# Access Compliance Report

## Public Rights-of-Way

Intersection ID: 24485	Main Street: CAMAROSS_DR	Cross Street: SAINTFIELD_PL	Location: NE
ADA ID: 1FC8746BC1E6	Ramp Type: Perp	Initial Pass/Fail: Fail	Overall Compliance: No
			Severity Score: 13.75

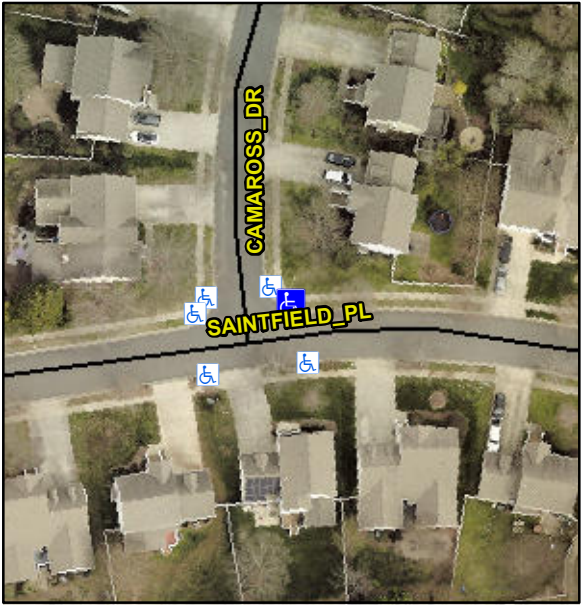
Codes/Mitigation Info/Possible Solution		Field Measurements/Component Compliance			
	Possible Solutions:				
	Remove & Replace Entire Ramp.				
	Surveyor Notes:				
	N/A				
	PROW/ADA:				
	R304.2.2, R304.5.3				
Street 1 Name	SAINTFIELD PL				
Stop Condition-Street 2	None				
Street 2 Name	N/A				
Stop Condition-Street 1	N/A				
Total Cost:		\$	1850.00

Compliance	Description	Data	Compliance	Description	Data
N/A	Ramp Length (in)	44.0	No	Ramp Slope (%)	8.4
Yes	Ramp Width (in)	48.0	No	Ramp XSlope (%)	3.1
N/A	Flare Type LT	N/A	N/A	Flare Type RT	N/A
N/A	Flare Slope LT (%)	N/A	N/A	Flare Slope RT (%)	N/A
N/A	Flare Traversable LT?	N/A	N/A	Flare Traversable RT?	N/A
N/A	Landing Length (in)	N/A	N/A	DWS Provided?	N/A
N/A	Landing Width (in)	N/A	N/A	DWS Contrast?	N/A
N/A	Landing Slope (%)	N/A	N/A	DWS Length (in)	N/A
N/A	Landing X Slope (%)	N/A	N/A	DWS Full Width?	N/A
N/A	Landing Curb? (Y/N)	N/A	N/A	DWS Offset (in)	N/A
N/A	Shared Landing?	N/A			
N/A	Gutter Ponding?	N/A	N/A	Gutter Slope (%)	N/A
N/A	Gutter Lip Ht (in)	N/A	N/A	Gutter X Slope (%)	N/A
N/A	Painted X Walk1?	No	N/A	Painted X Walk2?	N/A
	X Walk 1 Direction	To S		X Walk 2 Direction	N/A
N/A	X Walk 1 Width (in)	N/A	N/A	X Walk 2 Width (in)	N/A
	X Walk 1 Slope (%)	6.5		X Walk 2 Slope (%)	N/A
	X Walk 1 X Slope (%)	0.1		X Walk 2 X Slope (%)	N/A
